Cheltenham Borough Council Planning Application ref. 20/00683/OUT:
Woodland Trust (WT) comments of 12.06.20

Project Arboriculturist's Response

Planning application: 20/00683/OUT

Proposal: Outline application for 43 dwellings including access, layout and scale, with all other matters reserved for future consideration | Land Adjacent To Oakhurst Rise, Cheltenham, Gloucestershire

Figure 1 - Chart from page 4 of ATF leaflet 4, with FLAC mark-up (dashed red line)

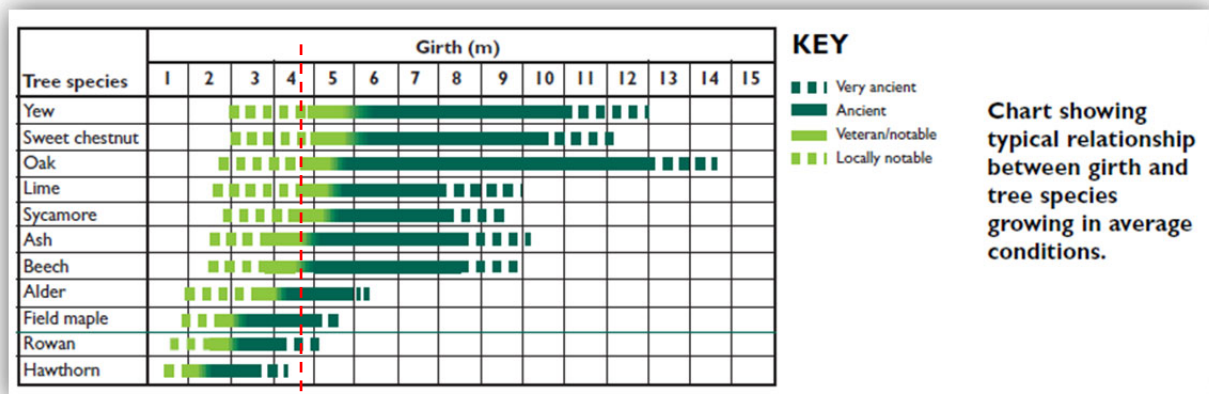
4) Moreover, on page 5 of Lonsdale, he provides a chart (Fig. 1.3) titled *Chart of girth in relation to age and developmental classification of trees*. This chart also appears in the Ancient Tree Forum Ancient Tree Guide Number 4, called *What are ancient, veteran and other trees of special interest*. We reproduce this chart as our Figure 1.

5) This chart (which is also Lonsdale Fig 1.3) shows that the unbreakable biological link between stem size and age is taken forward into tree developmental classification.

6) Insofar as the five allegedly omitted veteran trees are all pedunculate oak, it is instructed to look at the entry in the chart for this species. To aid interpretation, we have added a dashed red line at the onset threshold for veteran stem size, which is around 3.7m stem girth, or 1178mm diameter. Based on the accepted tree dating computation published by the Forestry Commission known as the White Method, for an average site a pedunculate oak of this size would be just under 200 years old, or ca. 25% of the low end of the species maximum in the UK (800-1000 years being the typical maximum longevity range). This is the stem size and estimated age threshold used by RAVEN which is, therefore, in full agreement with the chart.

Appendix 1. Veteran features of tree 3014 identified in August 2019

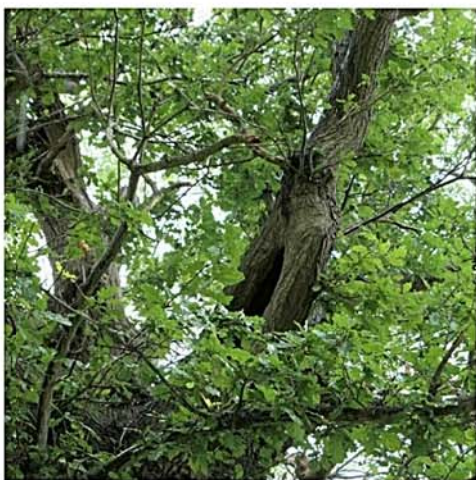
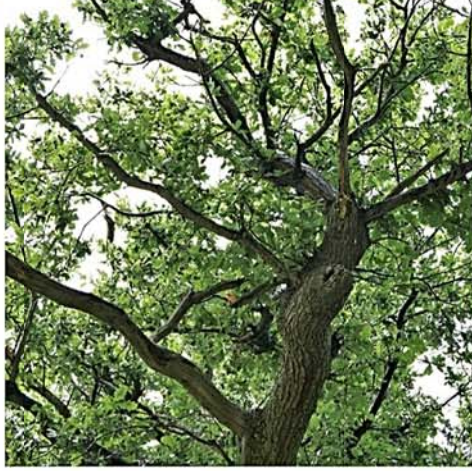
9 A particular example of this is tree T3014, an oak tree that has not been identified as a veteran tree by the applicants and so a Veteran Tree Buffer (VTB) zone has not been applied to this tree. We had the opportunity to assess this tree in August 2019. At that time, we noted a number of veteran features despite the tree girth not reaching a very large size⁵. This oak tree features a historic lightning strike, exposed heartwood, decay cavities, evidence of invertebrate use and presence of fungal fruiting bodies (please see Appendix 1 for further details and images).

- A) Wide view of tree 3014, showing condition of crown, with some large diameter dead wood and potential for retrenchment of upper crown.
- B) Historic lightning strike resulting in significant portion of exposed heartwood.
- C) Decay holes/ dry habitat space developing between sapwood and exposed heartwood.
- D) Large, accessible cavities high within tree crown
- E) Evidence of invertebrate activity including 'exit holes' in heartwood and accumulating decaying wood/ litter
- F) Fungal fruiting bodies of *Stereum gausapatum*, a heart rot species.

9. In this paragraph, the WT confirms that, despite alleging that five trees are omitted veterans, it only takes forward one tree to any level of detail, namely 3014. We agree that this tree has features of interest, but it does not meet two of the three criteria set out in the NPPF: it is not large and being less than 150 years old it is not old relative to others of its kind. The features which it exhibits cannot be said to comprise “exceptional” biodiversity value, a claim which even the WT does not make. It would, therefore, be both inaccurate and disproportionate to apply the protective policy at NPPF 175c to this tree.
